PP-2024-1465 | 146-150 Vimiera Road, Marsfield
Response to Request for Further Information

Attachment A – Detailed Response to RFI Letter

Re: PP-2024-1465 146-150 Vimieria Road, Marsfield – Response to Council RFI

RE: PLANNING PROPOSAL FOR 146-150 VIMIERA ROAD, MARSFIELD

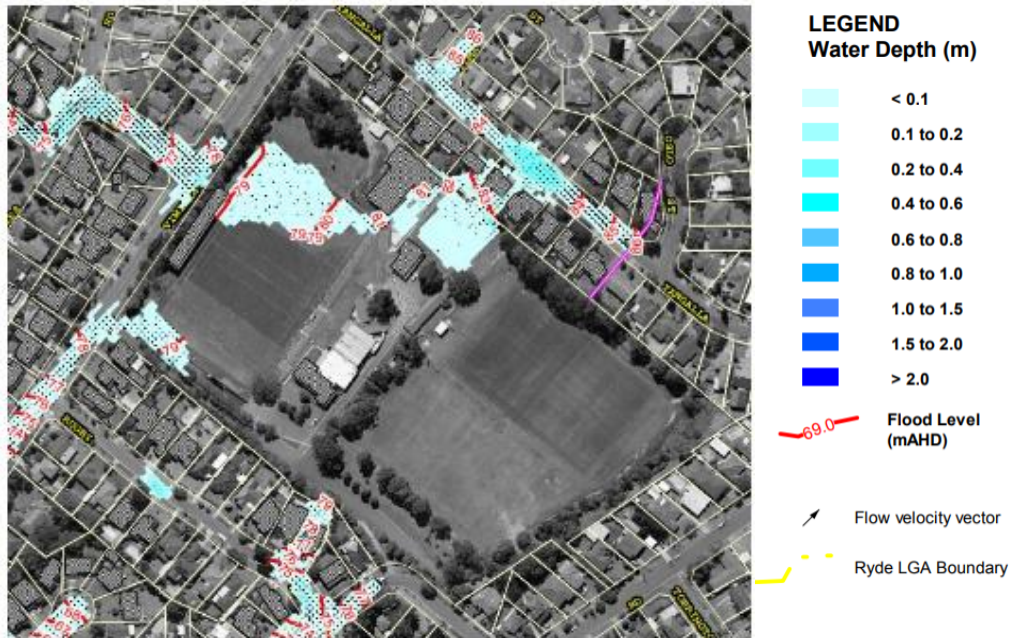
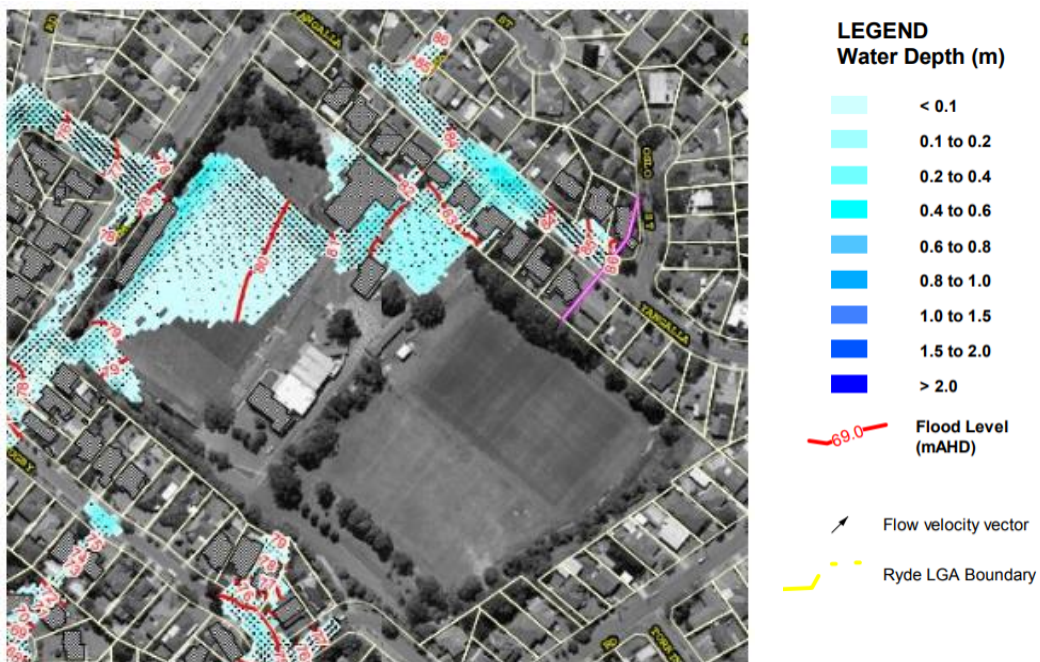
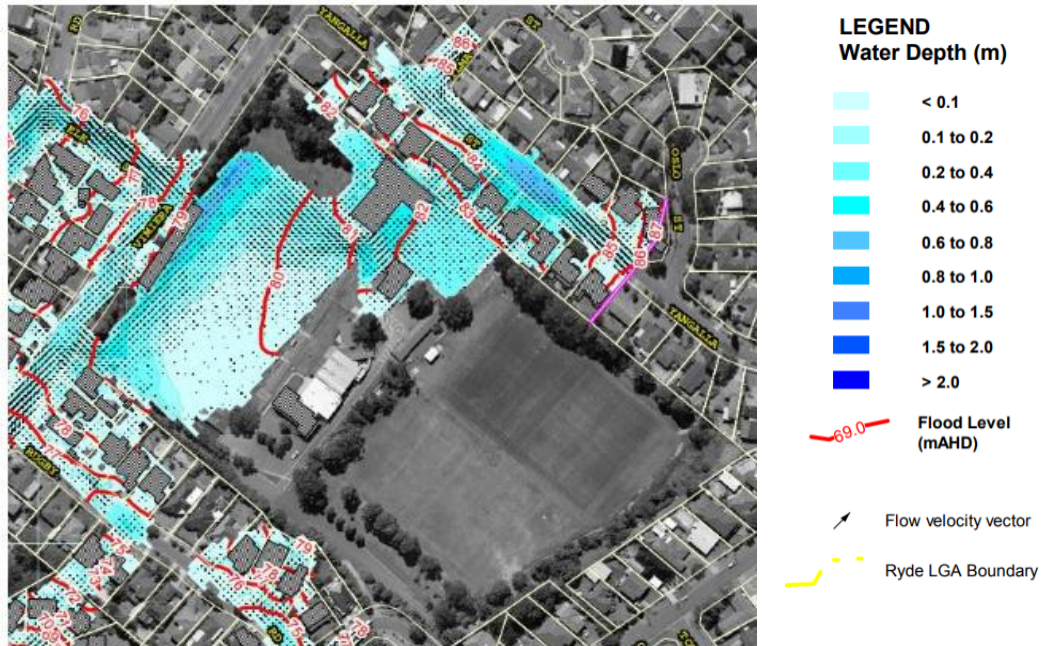
The portion of the site fronting Vimieria Road is affected by PMF and 20% AEP flood events. The proposal has been supported by a Stormwater Servicing Report produced by Northrop, dated 10/05/2022, which in summary notes that the proposal takes advantage of the site layout to implement flooding and Water Sensitive Design Solutions. It is noted this is the same report that was submitted with the 2022 Planning Proposal.

As the report does not provide pre- or post-development scenarios, it is unclear if the proposed R2 rezoning to the northwest and northeast will be located in flood prone land. Additionally, an assessment has not been provided on how the proposal is consistent with most recent flood planning considerations. The flooding across the north-eastern portion of the site also presents as a risk to resident egress and emergency access. Alternative access and egress arrangement may be required to demonstrate R2 viability. Council does not agree that this is a matter to be dealt with at DA stage. An updated report is required to demonstrate consistency with the Ministerial Direction 4.1 Flooding. It is understood Northrop are preparing a response to the matters raised above.

Included herein is a brief summary of the existing case flood behaviour, how the proposed development responds to stormwater and flooding considerations, and a response to the Ministerial Directions (Flooding).

Flood characteristics have been studied as part of the *Eastwood and Terrys Creek Floodplain Risk Management Study and Plan – Flood Study Report* prepared by Bewsher Consulting and dated 2008. The 20% AEP, 1% AEP, and PMF flood depths and elevations are presented below in Figures 1 to 3.

**Existing weekday morning
peak hour traffic flows**

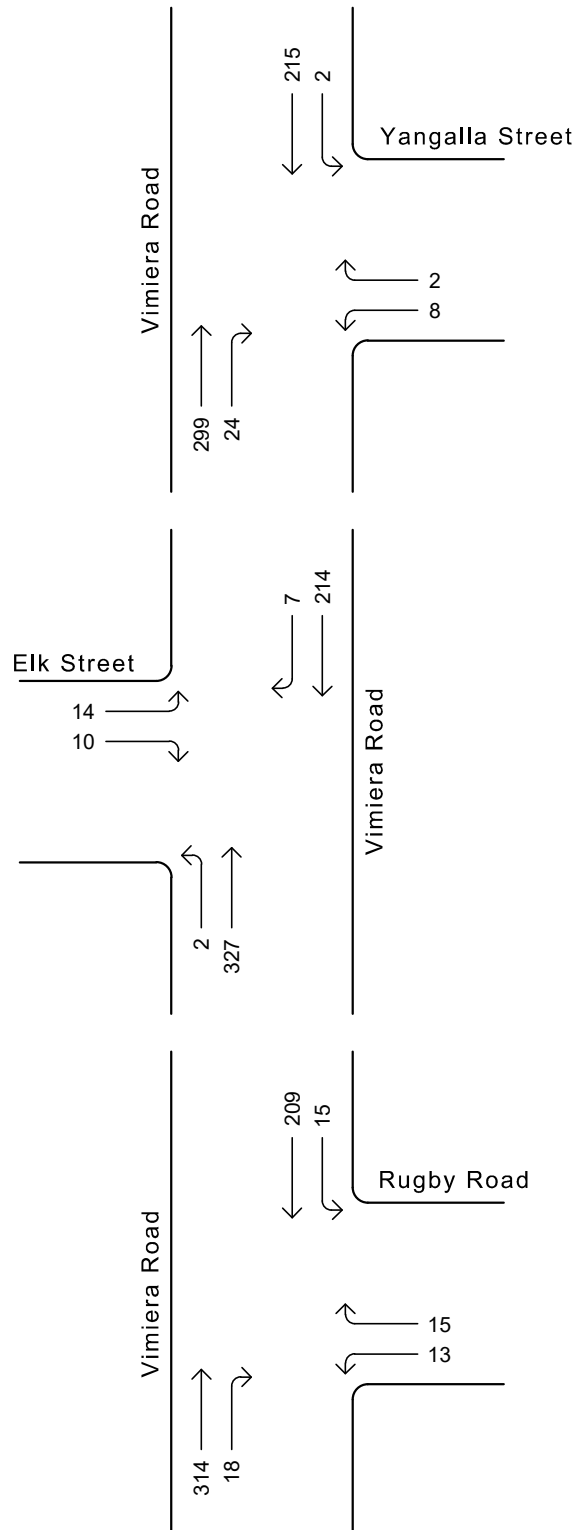
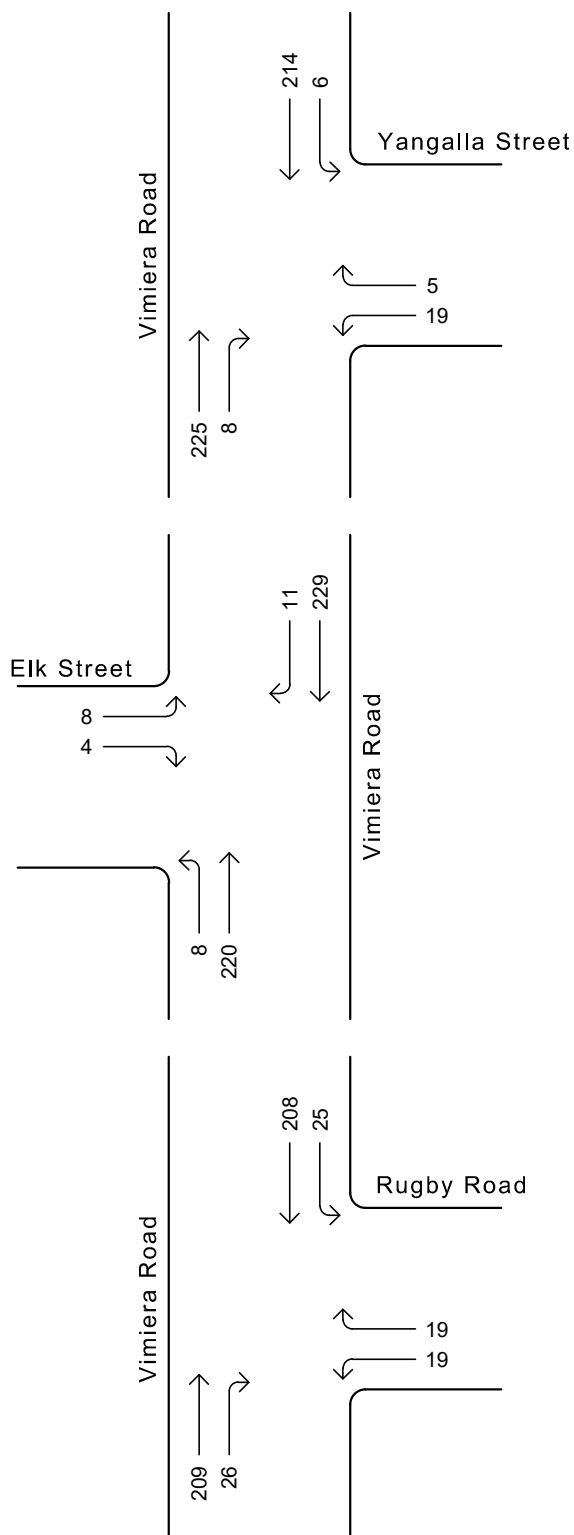
It is noted that the provided Traffic Impact Assessment report is the same as that submitted with the 2022 Planning Proposal. Considering the time past and changes to traffic behaviour, a review should be conducted to ensure the SIDRA modelling is still relevant.

- *A review of the provided SIDRA modelling to ensure the results are still relevant to current traffic conditions. This includes updated information based on current vehicular, pedestrian and cyclist traffic volumes during weekday and weekend peak periods.*
- *An amended and updated analysis in relation to public and active transport accessibility to demonstrate the site is well-located. This includes most up to date bus routes and walking routes and distances to public transport options.*

3. With regards to the first bullet point, updated traffic counts have been undertaken on Vimiera Road during weekday morning and afternoon peak periods in October 2024. The counts were undertaken at the following intersections:
- Vimiera Road/Yangalla Street;
 - Vimiera Road/Elk Street; and
 - Vimiera Road/Rugby Road.
4. The results of the surveys are shown in the attached Figures 1 and 2, and summarised in Table 1 below.

10. The analysis found that the unsignalised intersections of Vimiera Road with Yangalla Street, Elk Street and Rugby Road operate with average delays for all movements of less than 15 seconds per vehicle during morning and afternoon peak periods. This represents level of service A/B, a good level of service.

Bus Network Map

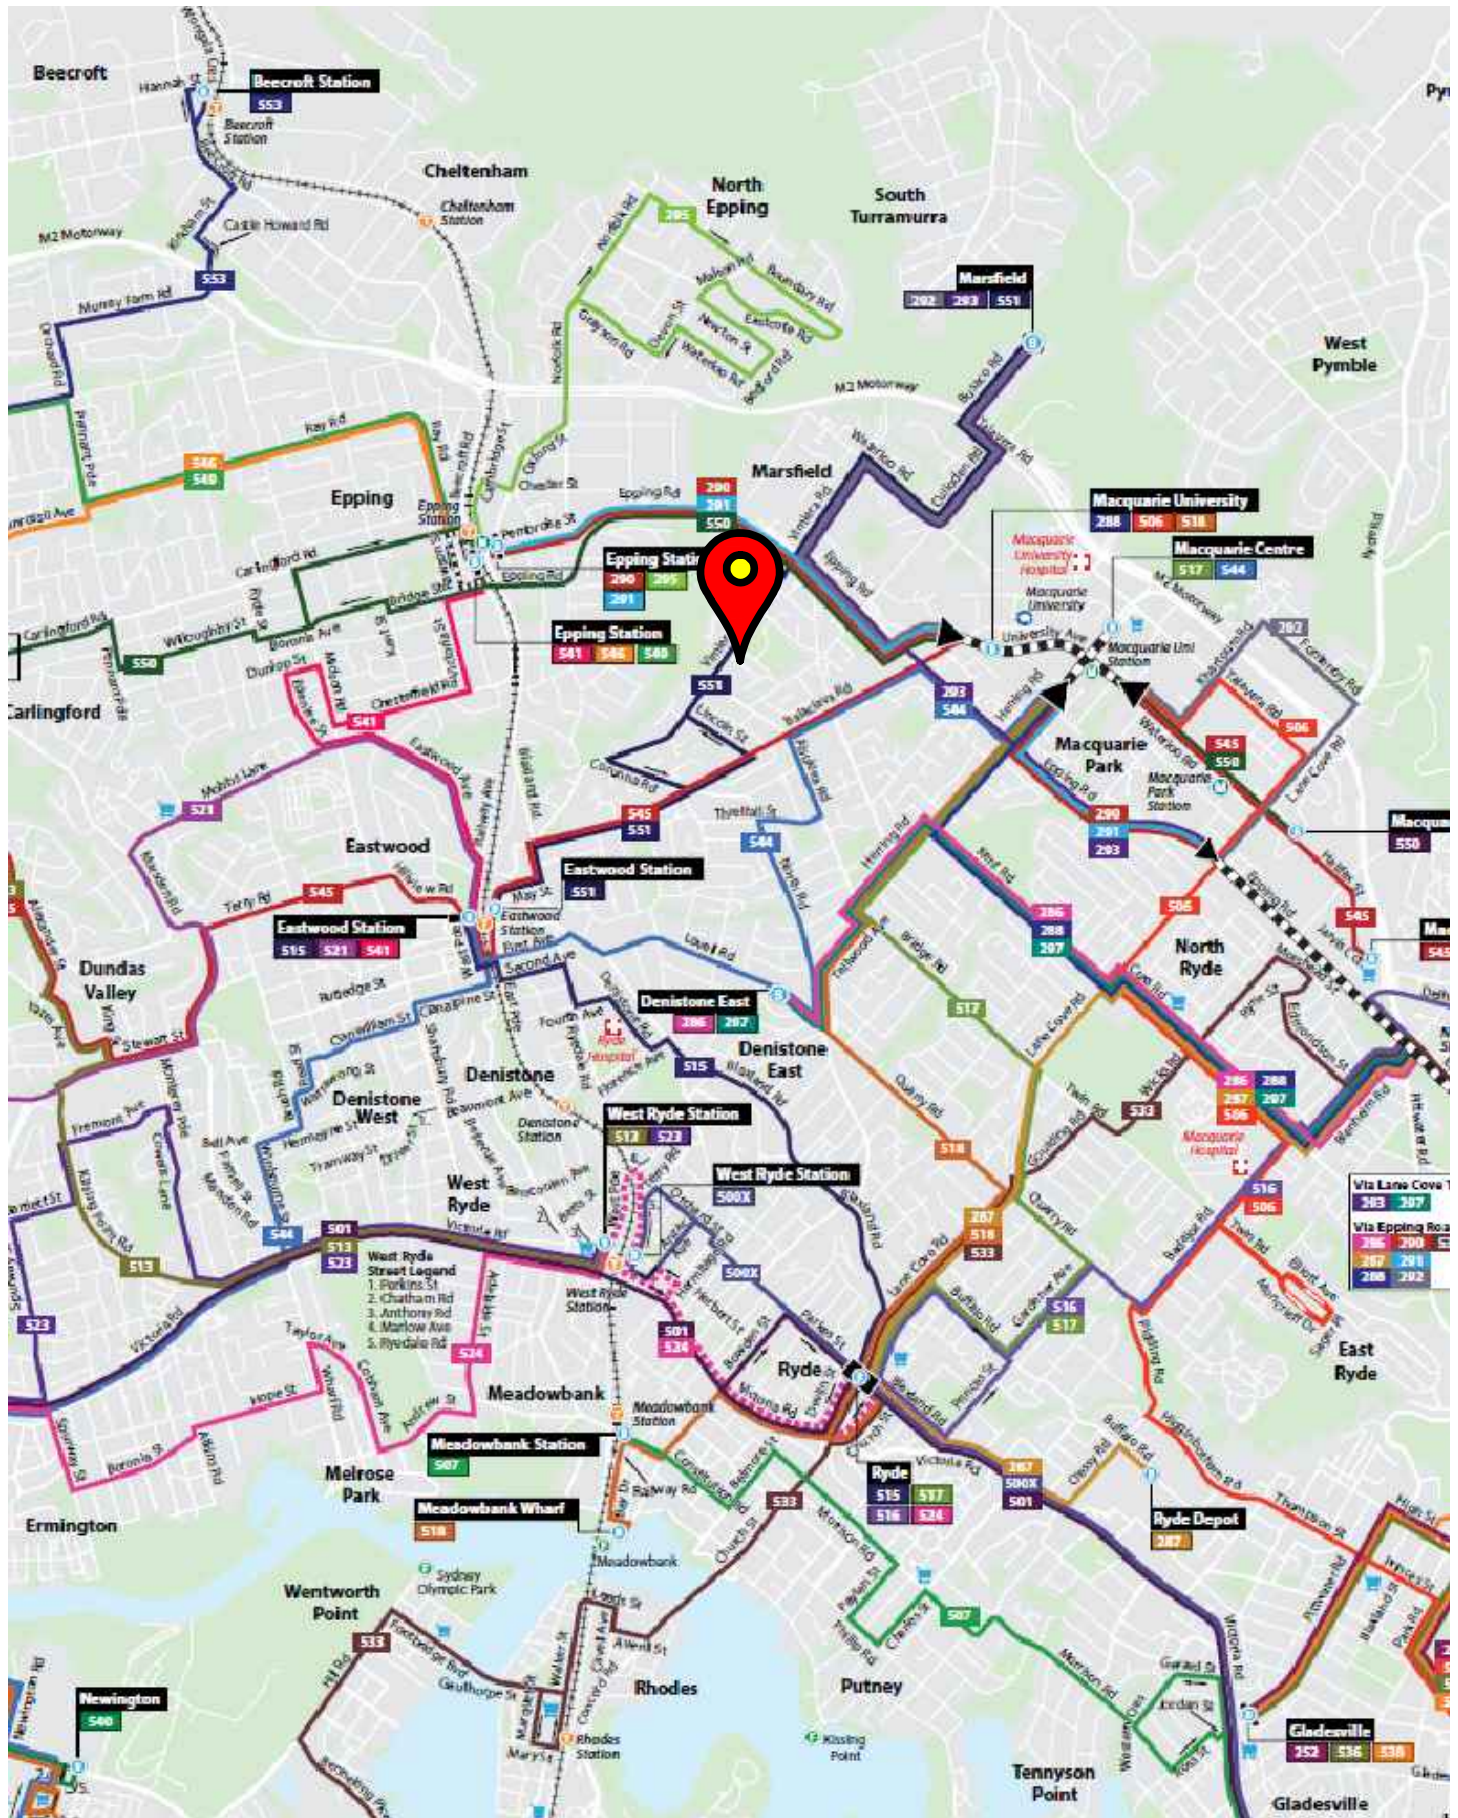
It is requested for this to be presented visually to help the Council and the community understand the sites transport characteristics.

16. Local bus services are provided by Busways North West. North of the site, Epping Road forms part of a major bus route between the city, North Sydney, Macquarie Park and other areas in the north-west. Services also operate along Vimiera Road, adjacent to the site.
17. Bus routes in the vicinity of the site are shown in Figure 5. There are bus stops on both sides of the road, immediately south of the site and footpaths on both sides of Vimiera Road which connect the site with these stops as well as Epping Road, some 500 metres to the north. Services include:
 - route 290: Epping to City Erskine Street via North Sydney (night service);
 - route 291: Epping to McMahons Point via North Sydney;

- route 292: Marsfield to City Erskine Street via Macquarie Park, Lane Cove North & Freeway;
 - route 293: Marsfield to City Wynyard via Lane Cove Tunnel;
 - route 550: Parramatta to Macquarie Park via Epping; and
 - Marsfield to Eastwood via Vimiera Road.
18. Figure 6 shows bicycle routes in the Ryde area. There is an existing on-road cycle lane on Vimiera Road, adjacent to the site. The landscape plan submitted with the application shows how an improved bicycle lane could be provided on the eastern side of Vimiera Road, along the site frontage.
